Millwood-Woodend Ratepayers Association

C 8
COMMUNICATION
CW (PH) - September 7, 2016
ITEM - 1

Re: **Applicant:** Centra (BT1) Inc.

File numbers: Z.16.010 and 19T-16V002

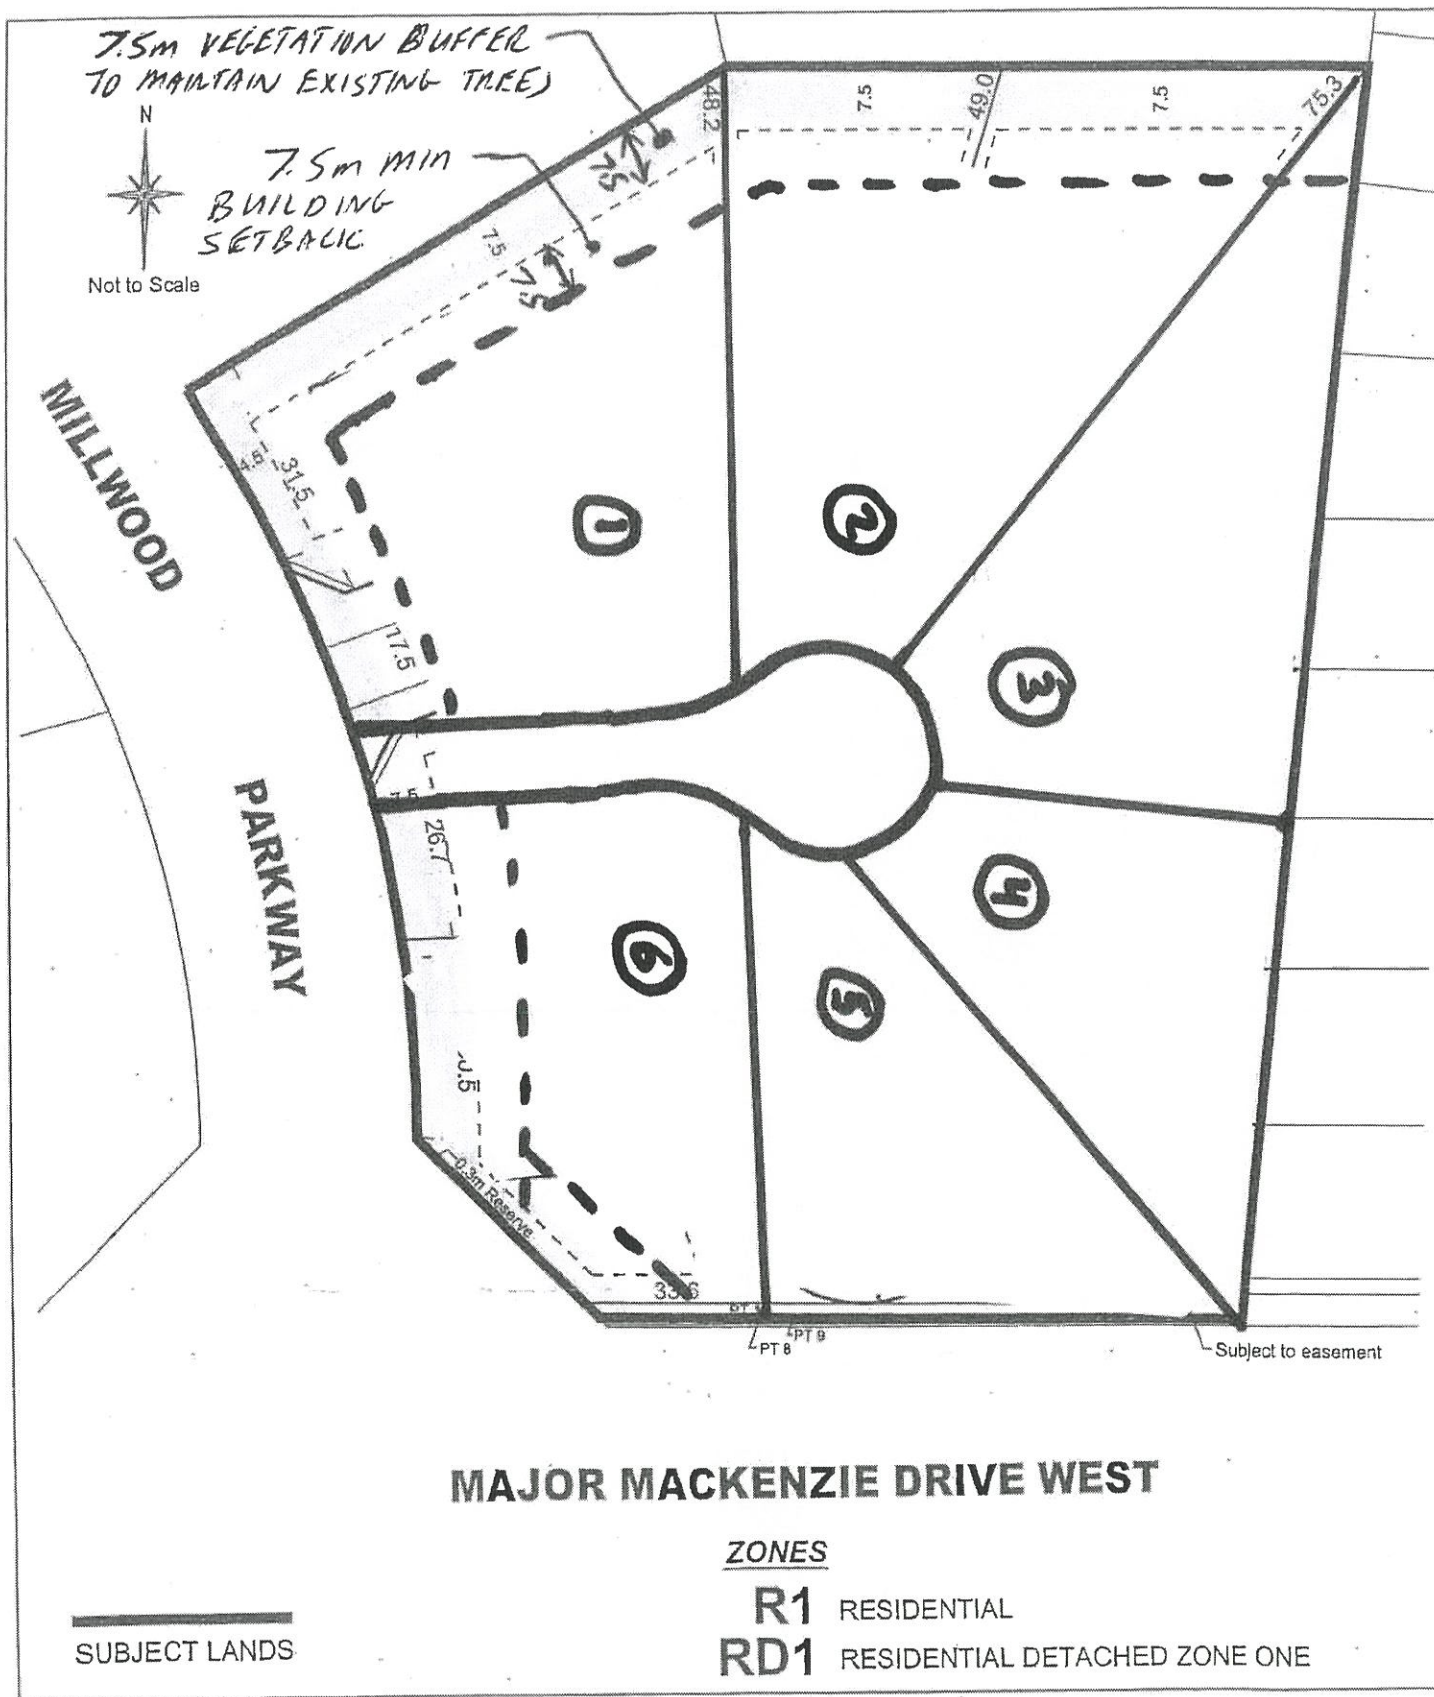
4. Proposed setbacks of homes are not consistent with the setbacks of homes in our neighbourhood. The Subdivision Agreement, guiding construction of homes in the third phase of the Millwood subdivision required a minimum setback of 30 m (measured from the front of our homes to the street line). Many homes within our subdivision are set back much further. In comparison, the proposed plan shows 10 m setbacks from the street line to the sides and back of homes. Similarly, homes were required to maintain a 30 m setback to the adjacent property lines. The proposed plan will have separations as little as 2.4 m between the homes.

5. Proposed rear setback of homes are not consistent with the rear setback of homes in the Hailsham subdivision. For the proposed homes backing on to Hailsham, the minimum setback is 7.5 m (measured from the backs of proposed homes to the rear lot line. This is significantly less than what exists along Hailsham today. Rear setbacks for these homes should be the same or greater than those along Hailsham.

Although we are adamantly opposed to the application as it stands, we would be supportive of a revised application which addresses the concerns raised above, and better fits within our neighbourhood. In particular, we request the following changes:

- Introduce a minimum vegetation buffer of 7.5 m – 10m from the street line and north perimeter to retain part of the 'woods' as seen when you enter Millwood, and to provide shielding between our existing neighbourhood and proposed homes. Grades within the buffer should not to be altered, to protect the existing trees, and additional evergreen trees should be planted to further enhance the shielding. The minimum City standard setback of 7.5 m should be measured from the edge of the vegetation buffer.

- Reduce the number of homes to provide additional green space for larger yards and more separation between houses. Although the applicant has tried to graduate the size of lots with smaller lots backing on to Hailsham and larger lots backing or siding on to Millwood, the resulting layout is that of a typical subdivision with minimal setbacks and yard widths, which is not in keeping with the existing character of Millwood Parkway.
